Docket No. 50-296

**BROWNS FERRY NUCLEAR PLANT (BFN) - UNIT 3 - REPLY TO NRC
REQUEST FOR ADDITIONAL INFORMATION (RAI) REGARDING AUGMENTED
REACTOR VESSEL WELD EXAMINATION (TAC NO. M91786)**

**TVA REPLY TO NRC REQUEST FOR ADDITIONAL INFORMATION
REGARDING AUGMENTED REACTOR VESSEL WELD EXAMINATION**

BROWNS FERRY UNIT-3 ID EXAMINATION

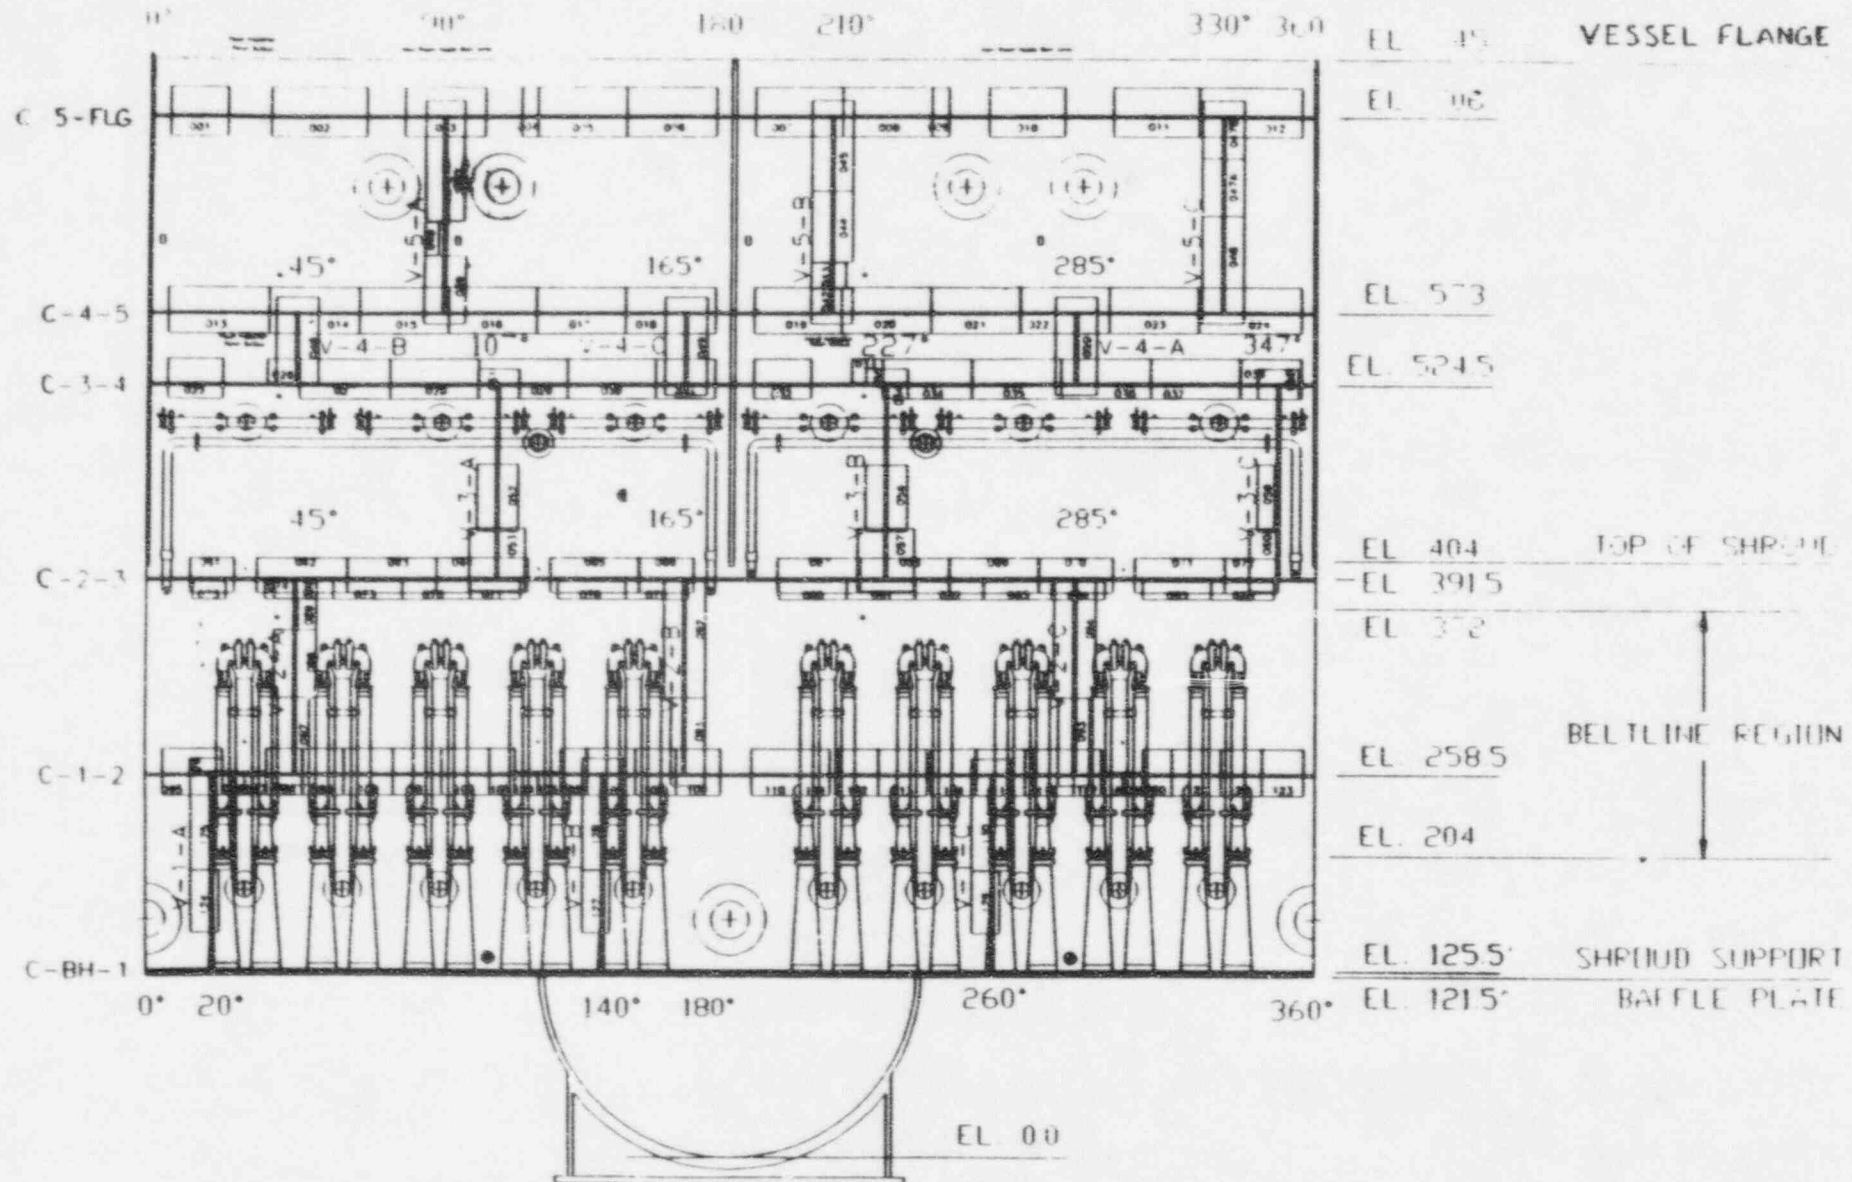
As a result of the above physical limitations, the following weld examination coverage was obtained:
Circumferential RPV Shell Welds (See Attachment 1)

Longitudinal RPV Shell Welds (See Attachment 1)

C-2-3: 80 percent
C-1-2: 90 percent
C-BH-1: 28 percent

V-1-A: 82 percent
V-1-B: 83 percent
V-1-C: 88 percent
V-2-A: 85 percent
V-2-B: 90 percent
V-3-C: 70 percent
V-4-B: 83 percent

C-4-5: 93 percent
C-3-4: 97 percent
V-2-C: 91 percent
V-3-A: 99 percent
V-3-B: 99 percent
V-4-A: 100 percent

V-4-C: 100 percent
V-5-A: 100 percent
V-5-B: 99 percent
V-5-C: 100 percent
